REVISION TO:
MASTER DEVELOPMENT
DRAINAGE PLAN
MERIDIAN RANCH
EL PASO COUNTY, COLORADO

June 2017

Prepared By:
Tech Contractors
11886 Stapleton Drive
Falcon, CO 80831
719.495.7444

FIGURE 5

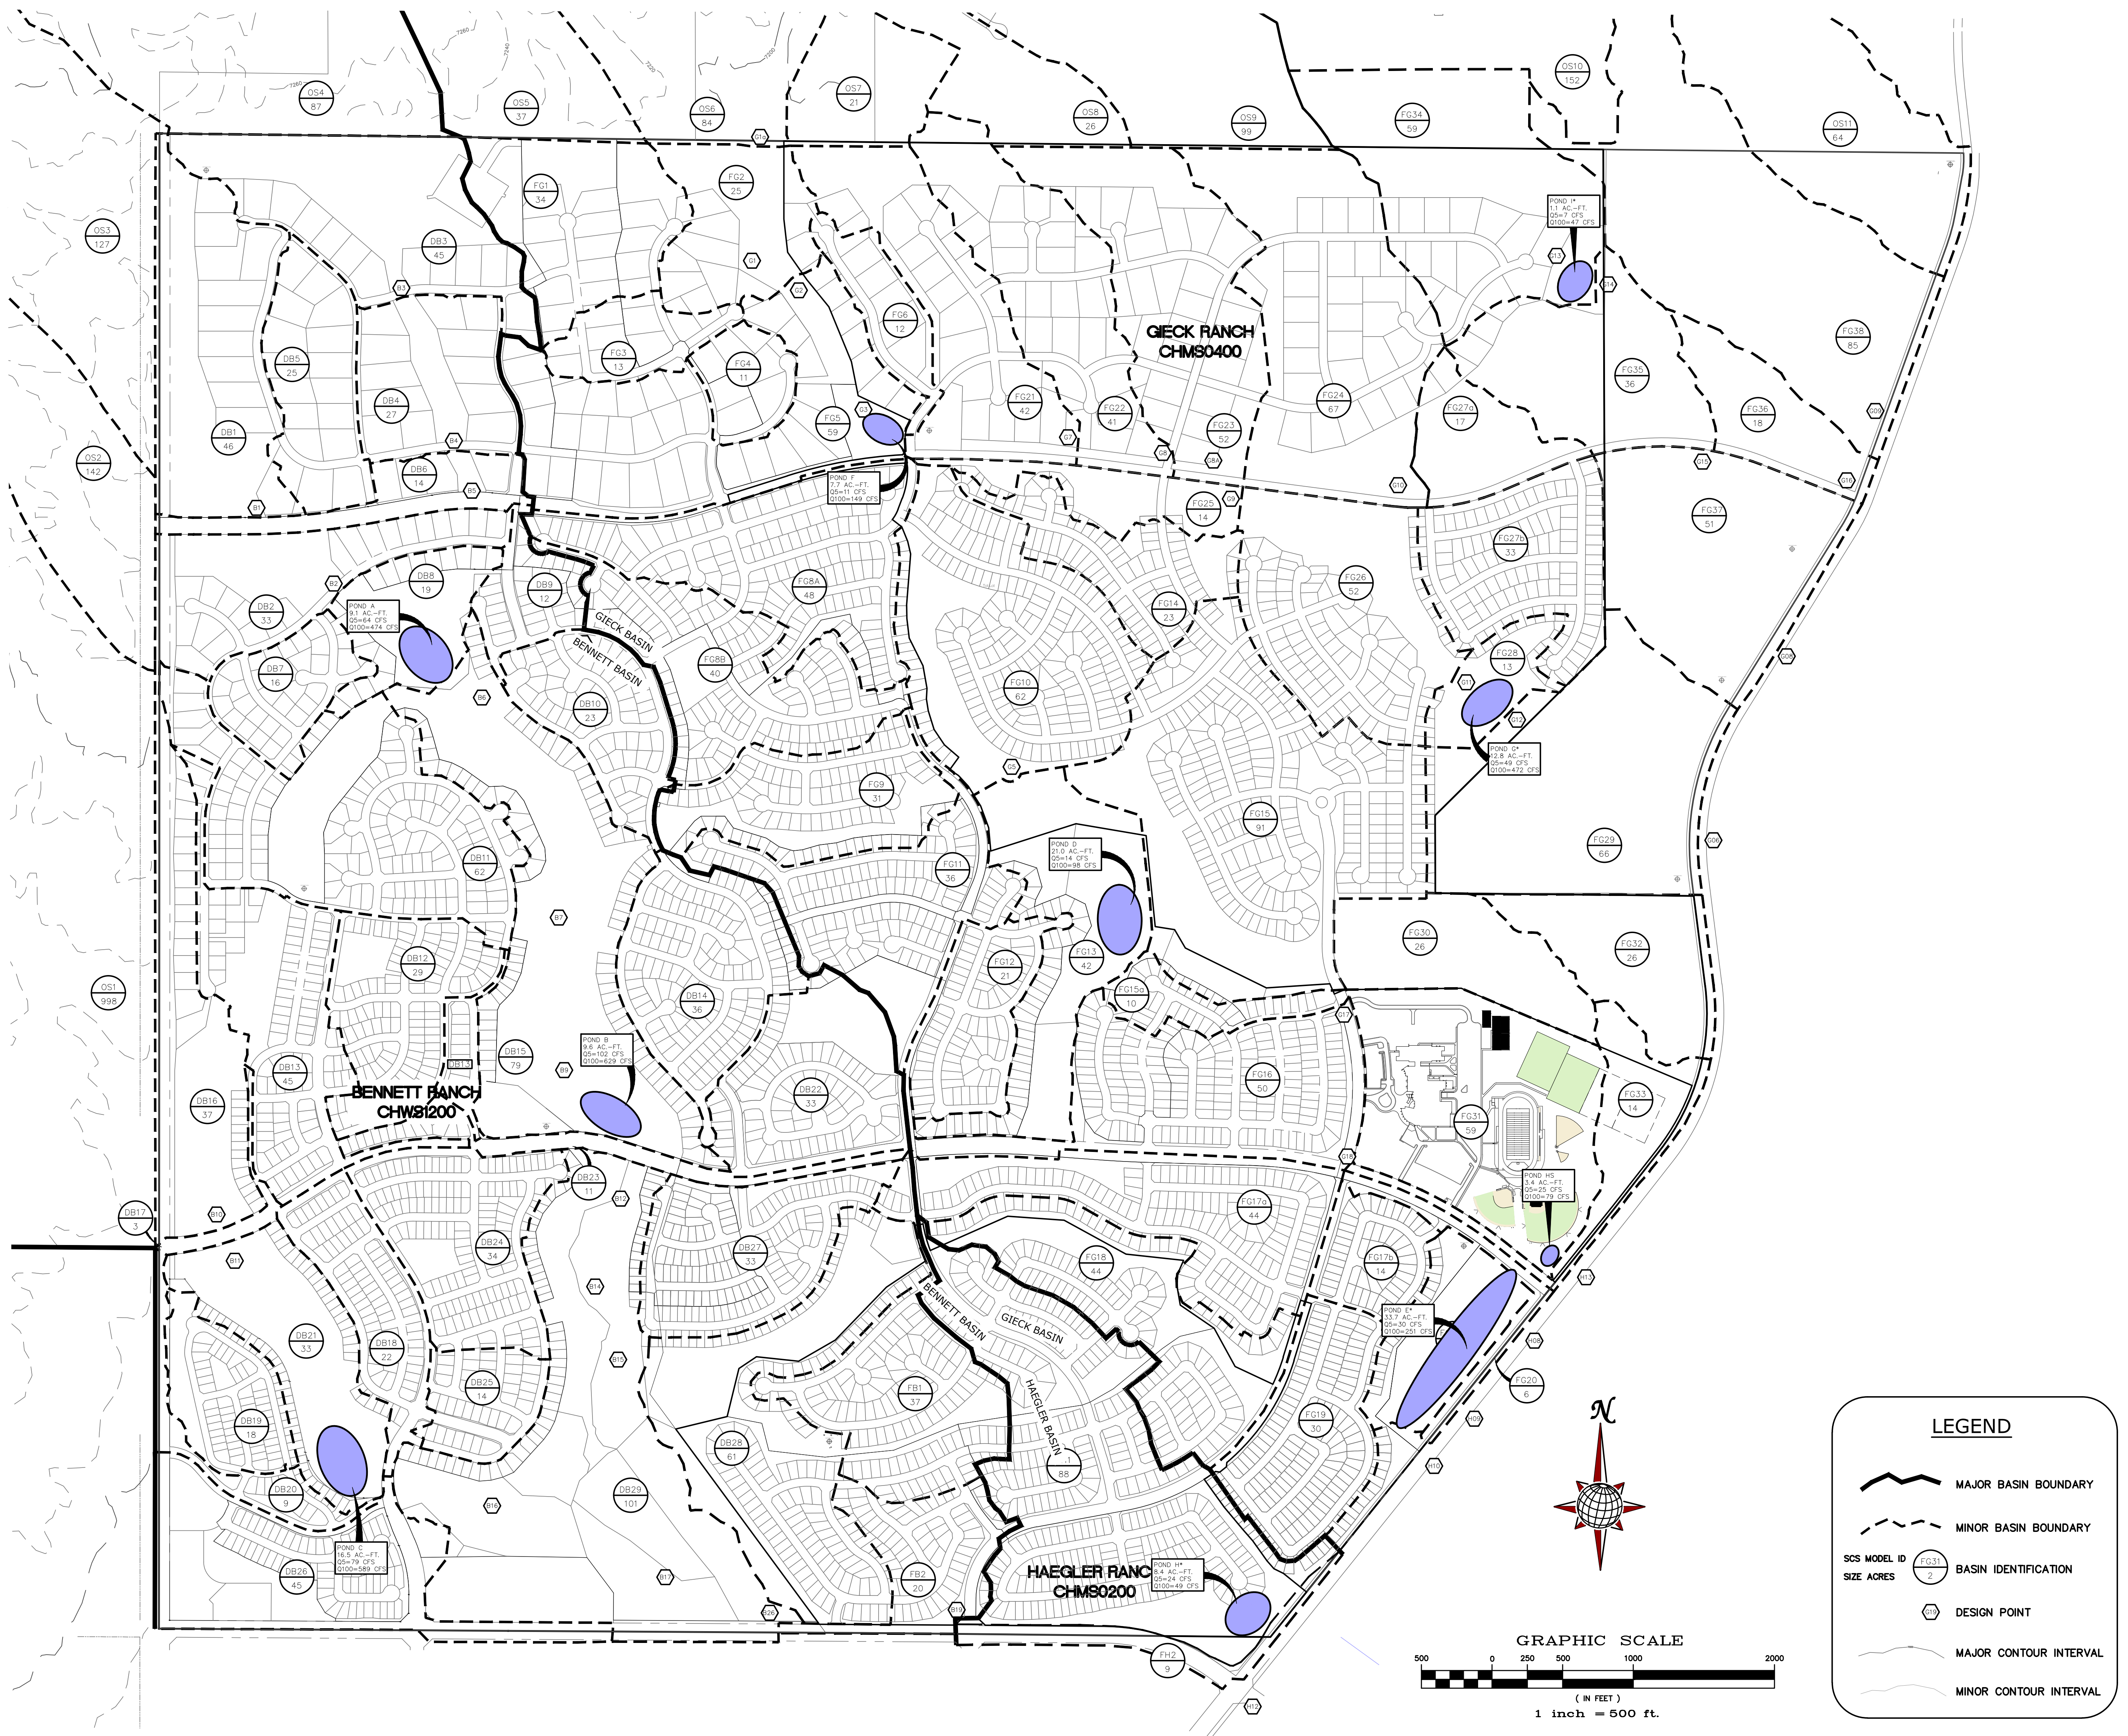
Revise. The calculations seem to be designed to release at historic rate.
Revise statement and note 90% of predevelopment per current Full Spectrum Detention criteria.

Revise. Per UDFCD DCM regarding Full Spectrum "The maximum allowable 100-yr release rate should not exceed 90% of the approved predevelopment release rate..."

Analyze and provide a narrative regarding the impact to downstream development moving forward with the design change to 90% release.

Add the schematic diagram in the appendix.
